Re: Response to Informal Conference Technical Analysis dated March 26, 2003,
Hiawatha Mine Complex, C/7007/011-AM02B-2

Response To Technical Analysis Dated March 26, 2003

Title: Hydrology Update (AM02B-2)

HIAWATHA MINE PLATE 5-2B

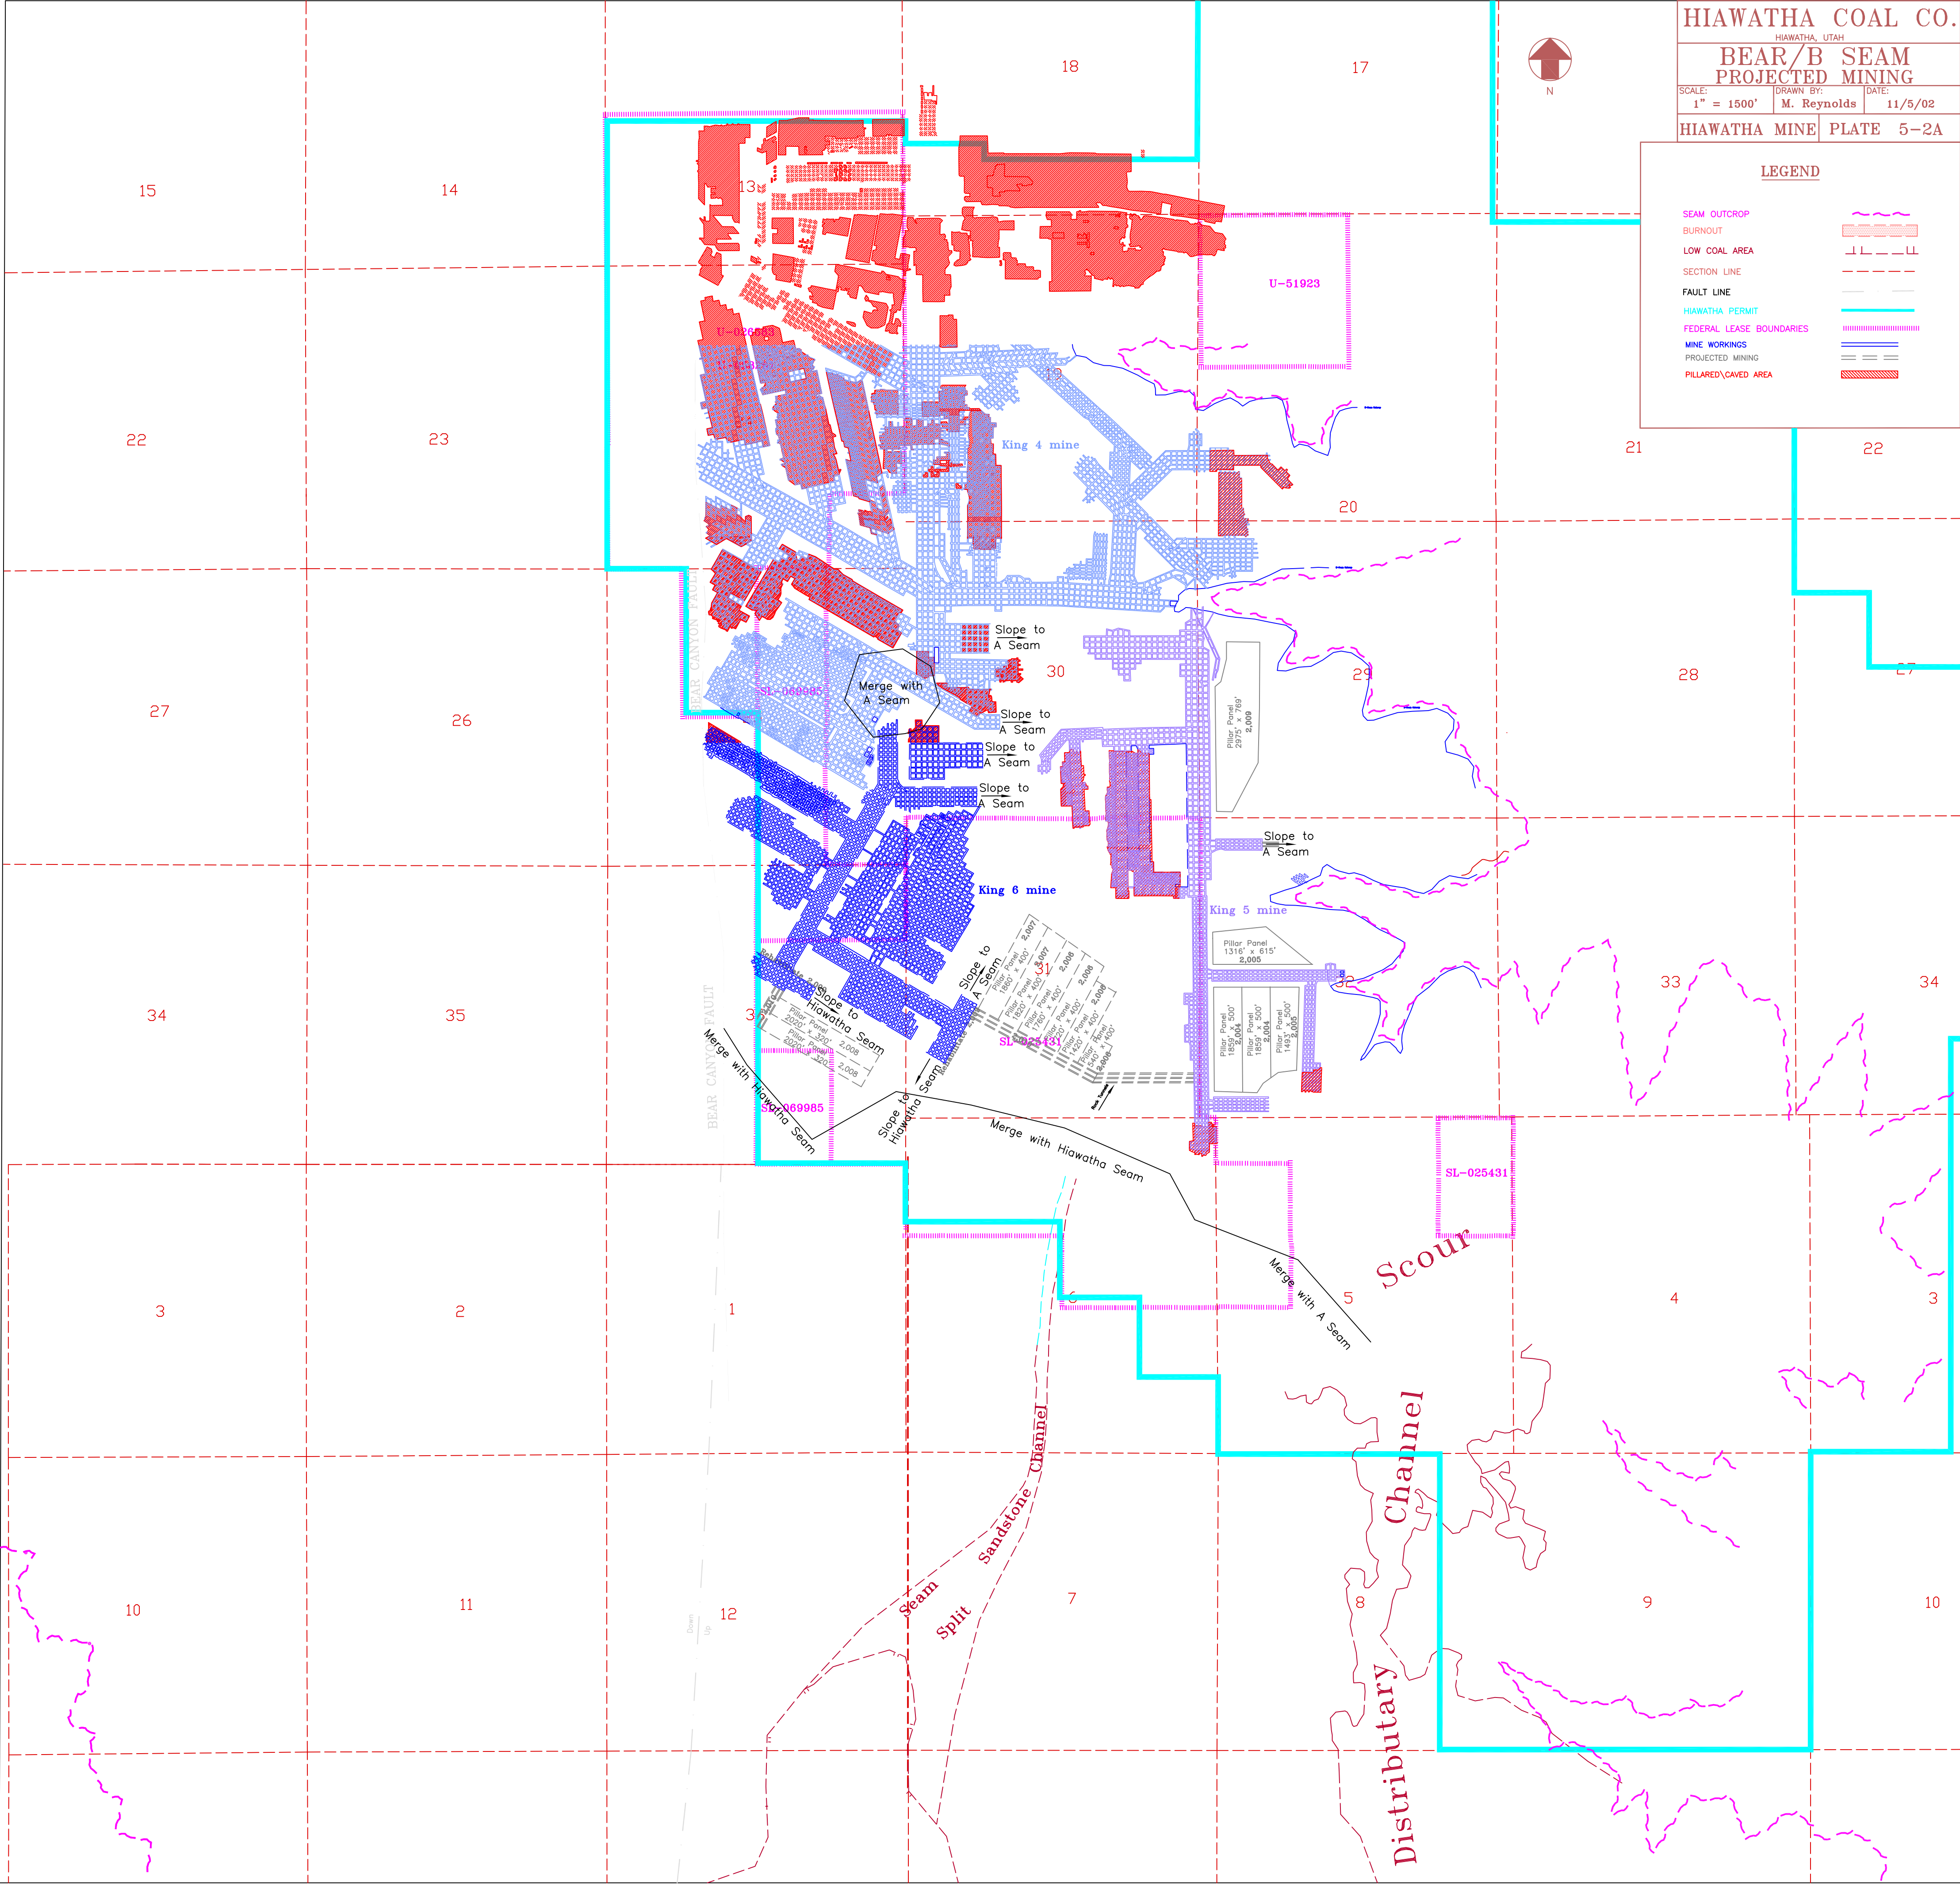
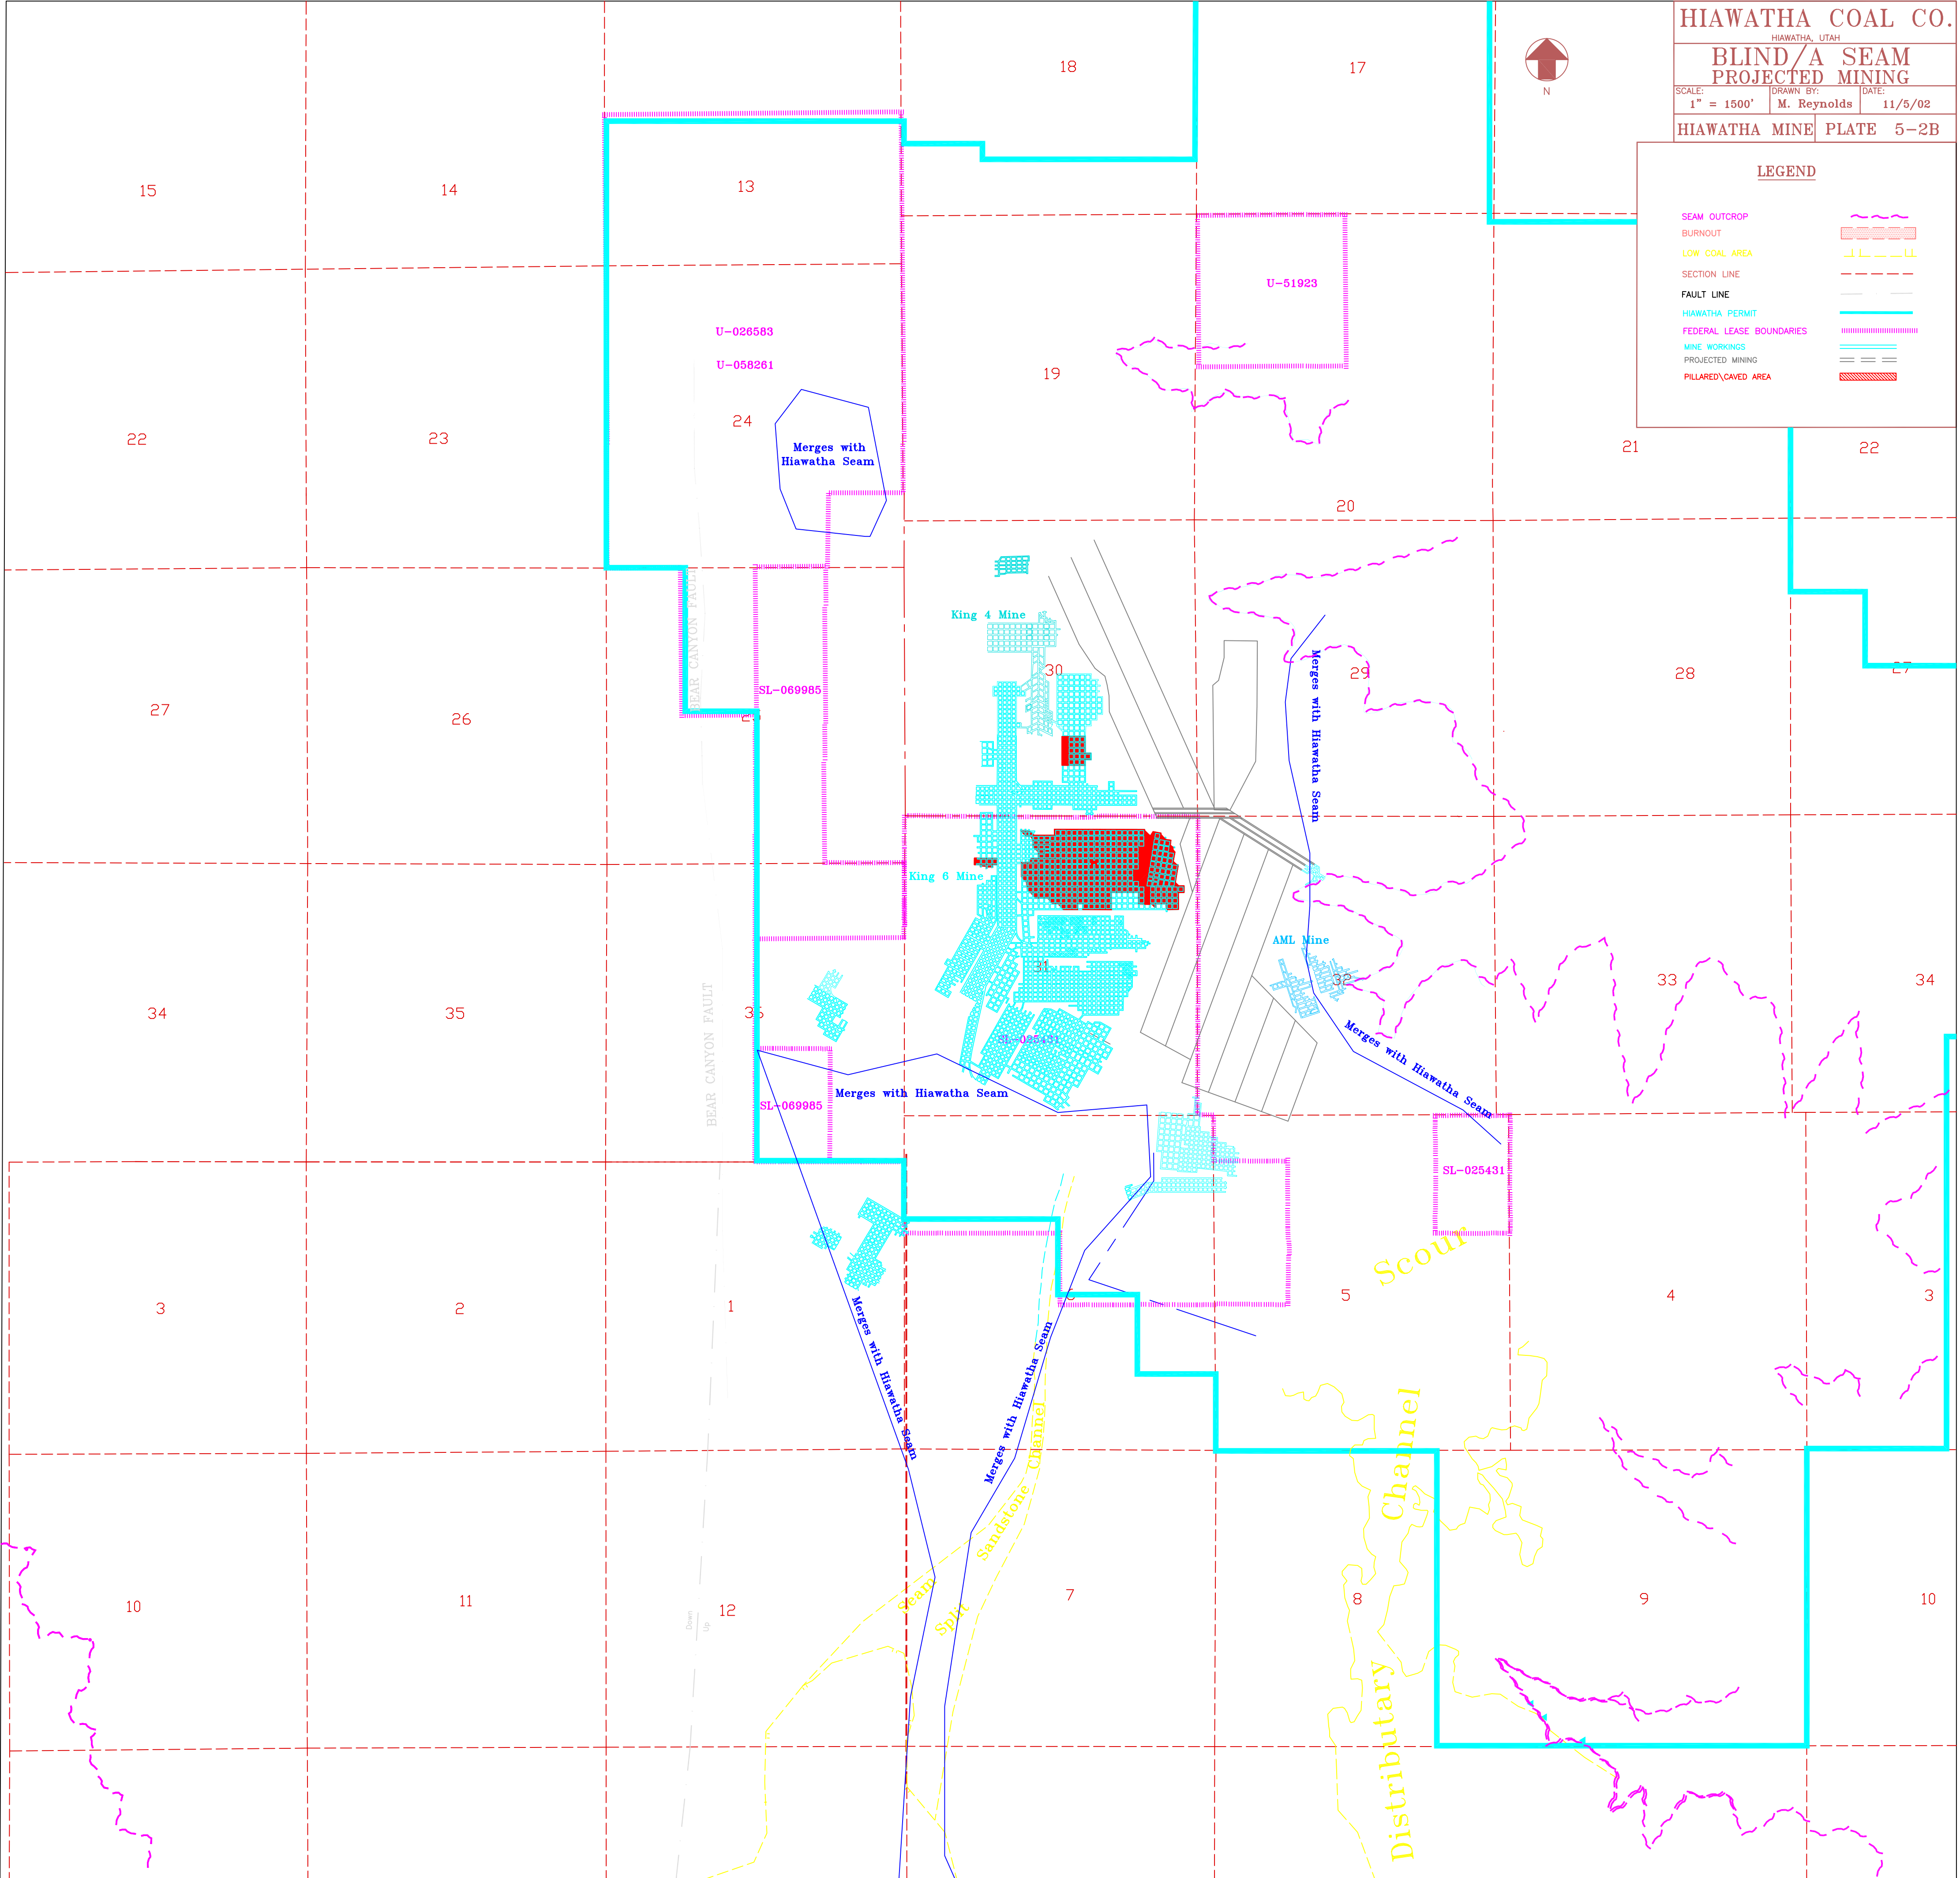
Pages 7-57 and 7-62 now reference Plates 5-1 and 5-2. Mine workings on the 5-2 plates were associated with their mine names.

HIAWATHA MINE PLATE 7-1

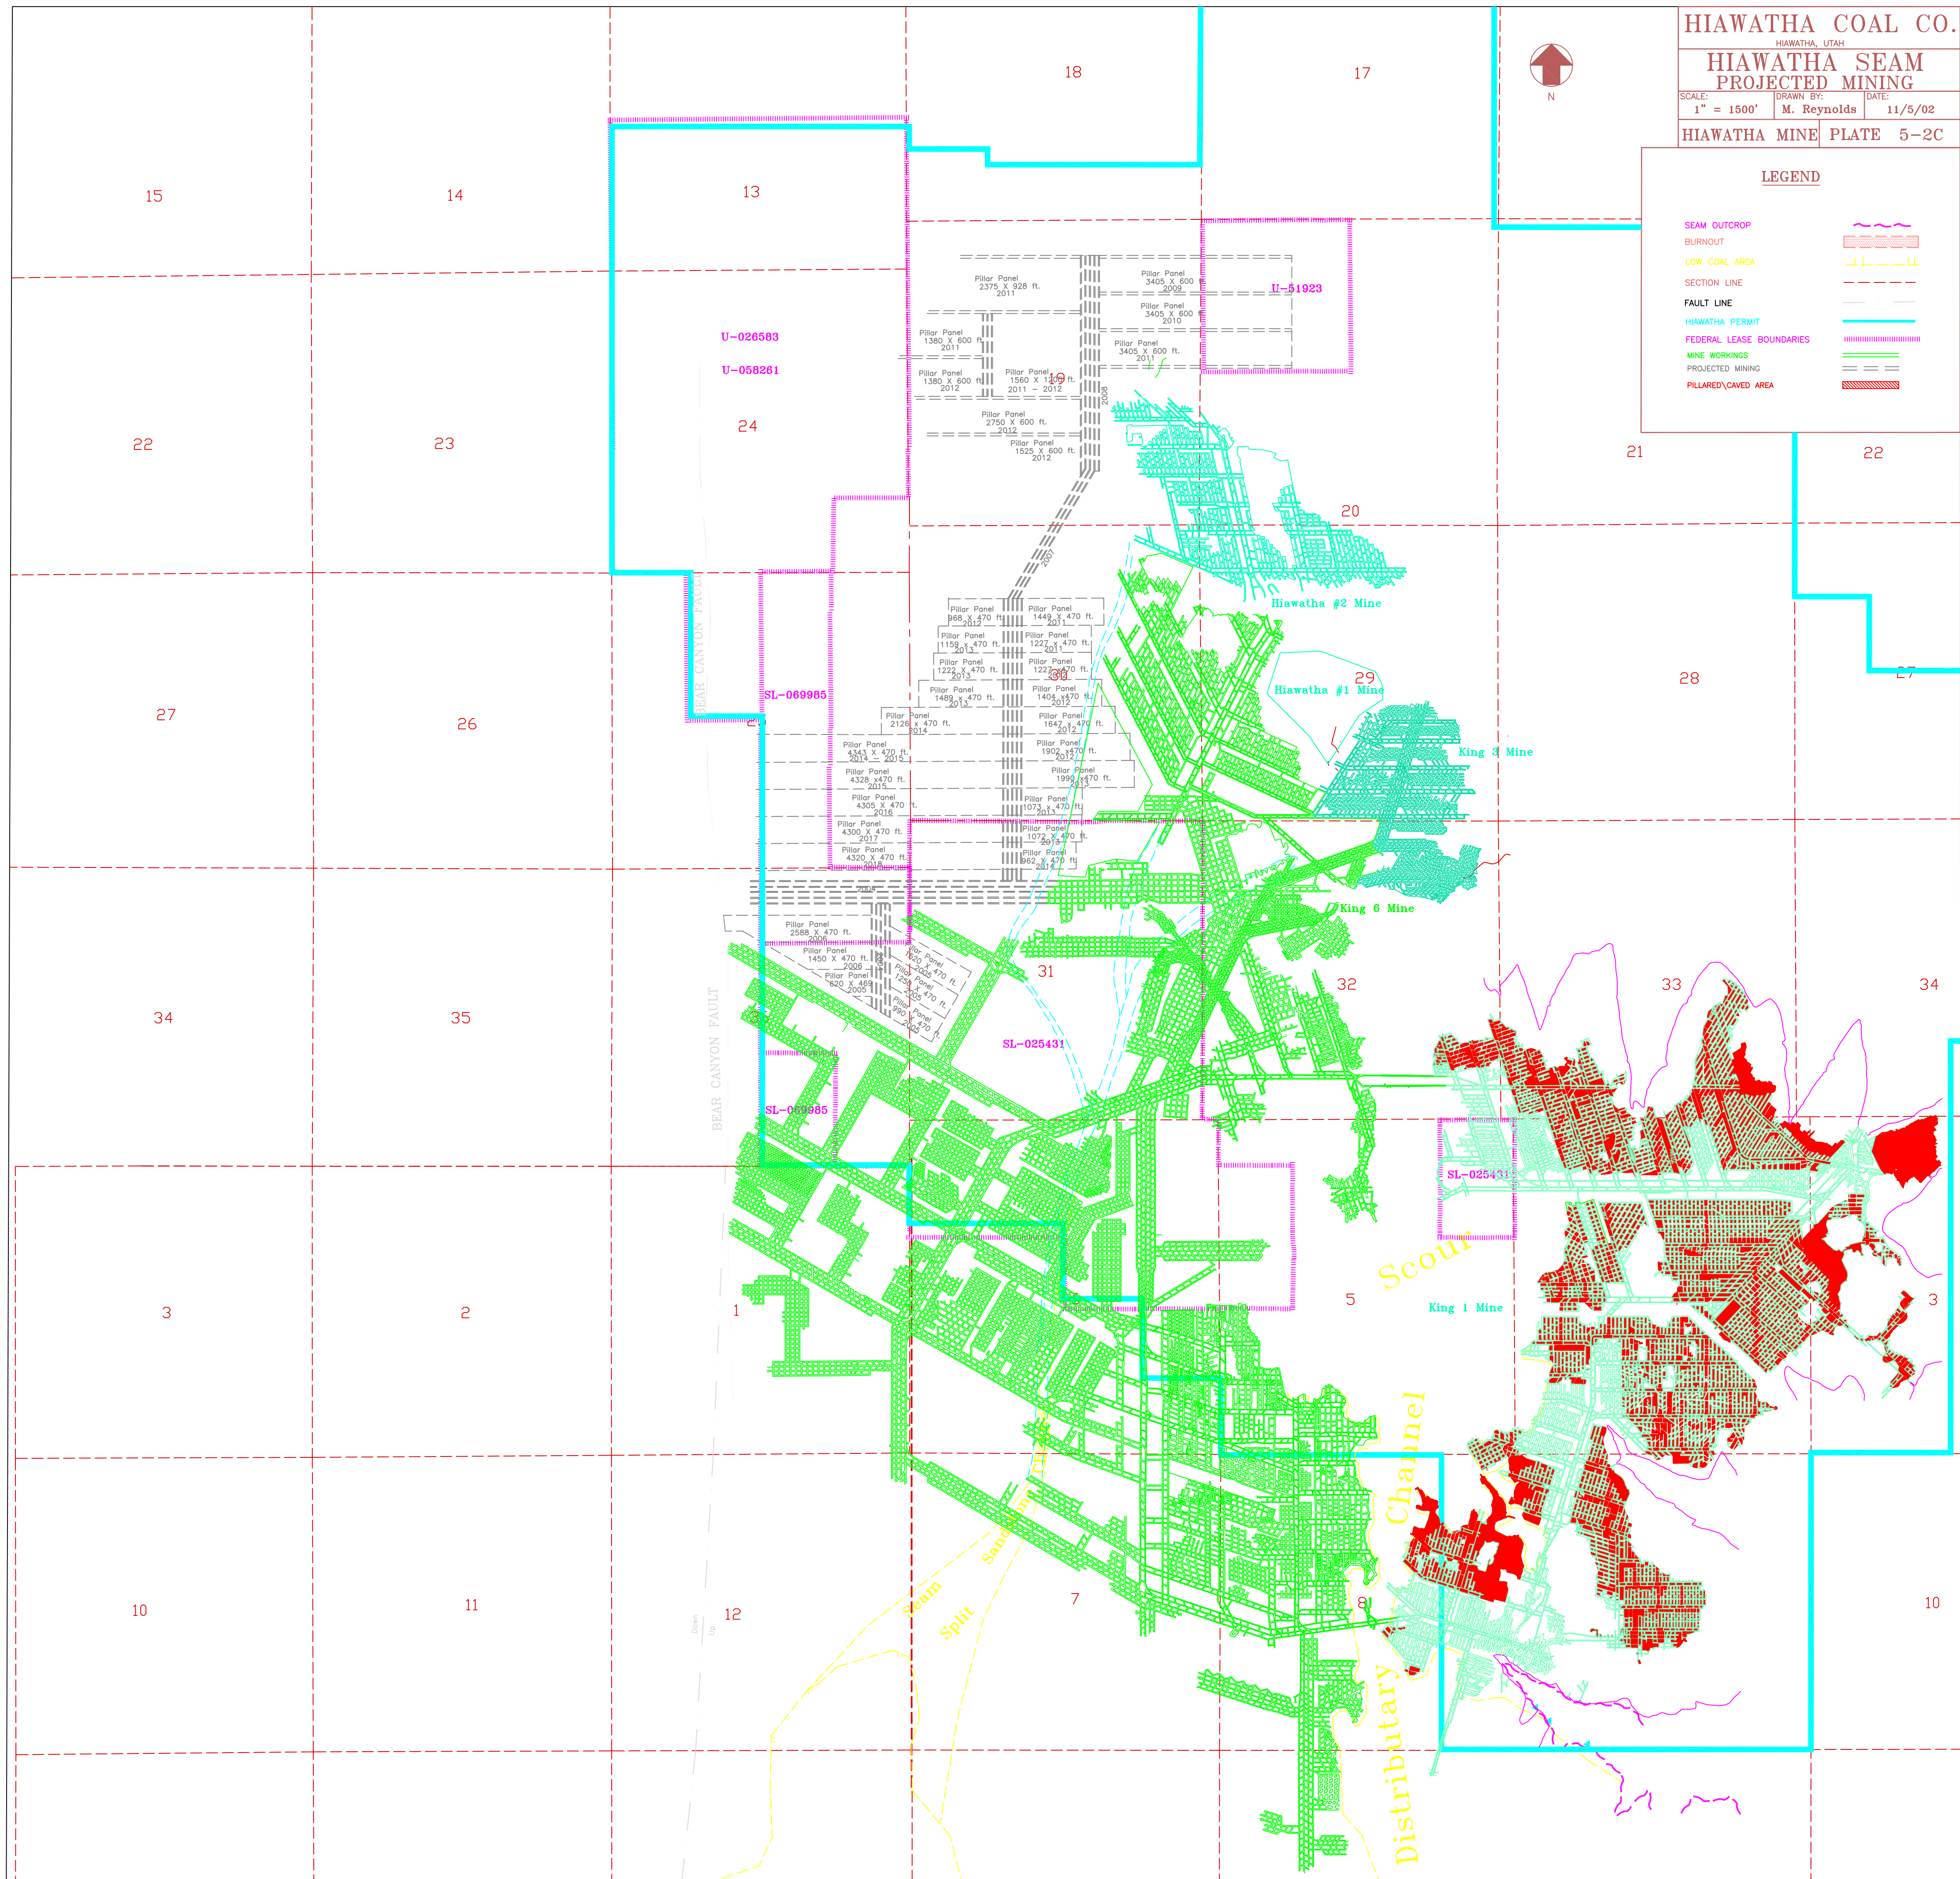
The requested changes have been made to Exhibit 7-1
